Changes in clause 86

Replace clause 86.7.4.7 with the following:

86.7.4.7 Transmitter optical waveform (transmit eye)

Figure 86-4—Transmitter eye mask definition

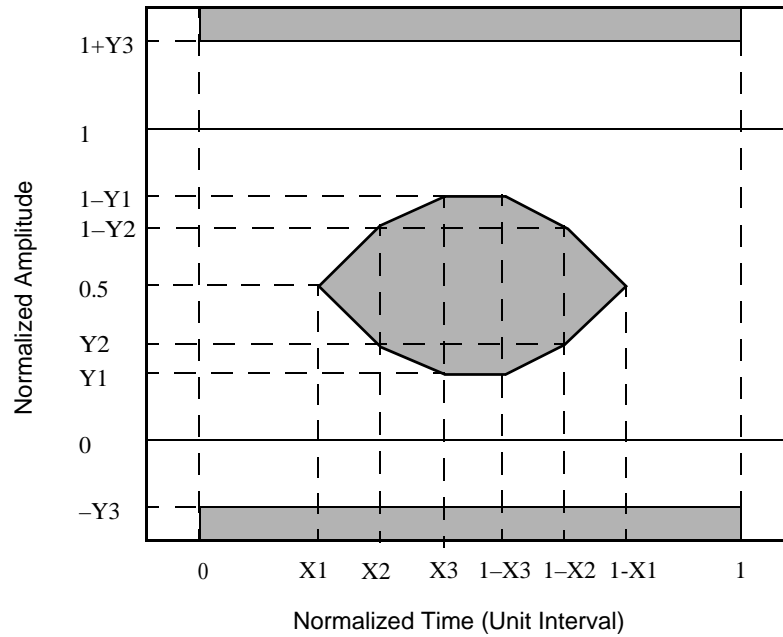
The required optical transmitter pulse shape characteristics are specified in the form of a mask of the transmitter eye diagram as shown in Figure 86-4. The transmitter optical waveform of a port transmitting the test pattern specified in Table 86-15 shall meet specifications according to the methods specified in 86.7.4.7.1 with the filter nominal reference frequency f_r of 7.5 GHz and filter tolerances as specified for STM-64 in ITU-T G.691. Measurements during system operation or with other patterns, such as TBD signal, are likely to give very similar results.

The eye is measured with respect to the mask shown in Figure 86-4 using a receiver with the fourth-order Bessel-Thomson response having a transfer function given by Equation (86-1) and Equation (86-2):

Normalized amplitudes of 0 and 1 represent the amplitudes of logic ZERO and ONE respectively. These are defined by the means of the lower and upper halves of the central 0.2 UI of the eye. Normalized times of 0 and 1 on the unit interval scale are determined by the eye crossing means measured at the average value of the optical eye pattern. A clock recovery unit (CRU) should be used to trigger the oscilloscope for mask measurements, as shown in Figure 52-9. It should have a high frequency corner bandwidth as specified in Table 86-16 and a slope of -20 dB/decade. The CRU tracks acceptable levels of low-frequency jitter and wander.

The transmitter shall achieve a hit ratio lower than 5×10^{-5} hits per sample, where “hits” are the number of samples within the grey areas of Figure 68-6, and the sample count is the total number of samples from 0 UI to 1 UI. Some illustrative examples are provided in 86.7.4.7.2.

In Table 86-8 set {X1, X2, X3, Y1, Y2, Y3} to {0.25, 0.40, 0.45, 0.25, 0.28, 0.40} with editor's note that the numbers are provisional.

[Editor's note (to be removed prior to publication) - Details of the transmit eye mask measurement are being studied by the Statistical Eye Ad Hoc and consequently the contents of this clause together with the mask parameters in Table 86-8 are provisional.]
